APPLICATION NO.	FILING DATE	FIRST NAMED INVENTOR	ATTORNEY DOCKET NO.	CONFIRMATION NO.
10/788,740	03/01/2004	Daxiong Ji	967AAF	6104
7590	07/28/2005			
Kevin Redmond 6960 SW Gator Trail Palm City, FL 34990			EXAMINER GLENN, KIMBERLY E	
			ART UNIT 2817	PAPER NUMBER

Office Action Summary	Application No. 10/788,740	Applicant(s) JI, DAXIONG	
	Examiner Kimberly E. Glenn	Art Unit 2817

DETAILED ACTION

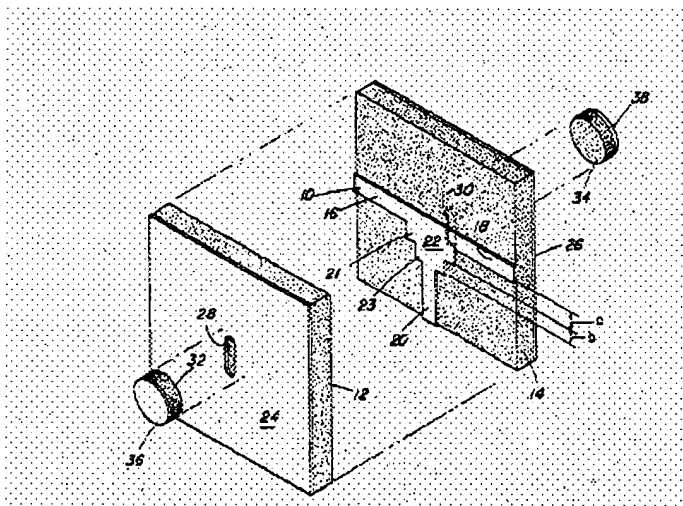
The drawings are objected to because in figure 1-- Prior Art-- is spelled incorrectly. Corrected drawing sheets in compliance with 37 CFR 1.121(d) are required in reply to the Office action to avoid abandonment of the application. Any amended replacement drawing sheet should include all of the figures appearing on the immediate prior version of the sheet, even if only one figure is being amended. The figure or figure number of an amended drawing should not be labeled as "amended." If a drawing figure is to be canceled, the appropriate figure must be removed from the replacement sheet, and where necessary, the remaining figures must be renumbered and appropriate changes made to the brief description of the several views of the drawings for consistency. Additional replacement sheets may be necessary to show the renumbering of the remaining figures. Each drawing sheet submitted after the filing date of an application must be labeled in the top margin as either "Replacement Sheet" or "New Sheet" pursuant to 37 CFR 1.121(d). If the changes are not accepted by the examiner, the applicant will be notified and informed of any required corrective action in the next Office action. The objection to the drawings will not be held in abeyance.

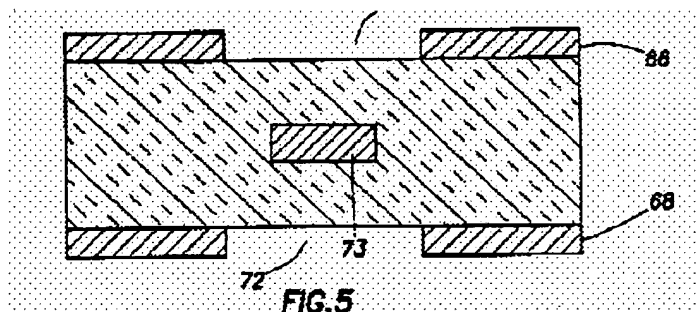
Wright disclose in figure 1, a trace disposed in a dielectric layer and flanked on the top and the bottom by conductive layers 66, and 68. Each of the conductive layers has an array of windows. The windows are located symmetrically with respect to traces 73. The characteristic impedance of the line depends on the dimension of the slots (windows) and the spacing between the slots. ^{col} 16, ^{lines} column 34-43 and column 5 lines 29-34)

One of ordinary skill in the art would have found to obvious to replace to general conductive materials of Plunk et al with the conductive layers having an array of windows as taught by Wright et al. The motivation for this modification would have been to control the impedance of the conductors.

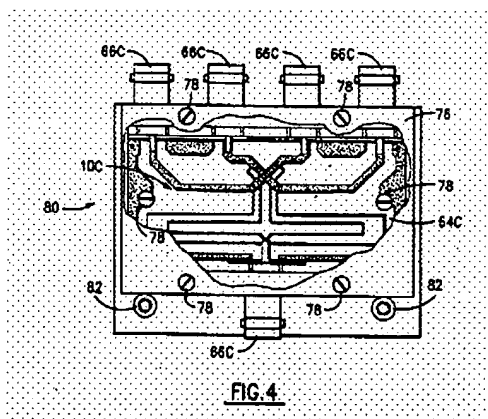
Gustafson disclose in figure 4, a splitter (divider) disposed in a housing 76 (case). The splitter circuit board is mounted in the housing using mounting hardware 78.

One of ordinary skill in art at the time of the invention would have found to obvious to place the divider of Plunk et al in the housing as taught by Gustafson. When the dielectric layers of Plunk et al are placed in the housing by the mounted hardware. The conductive material will be connected to the case. The motivation for this modification would have been the provided the advantageous benefit of circuit protection from environmental factors (dust, water etc).
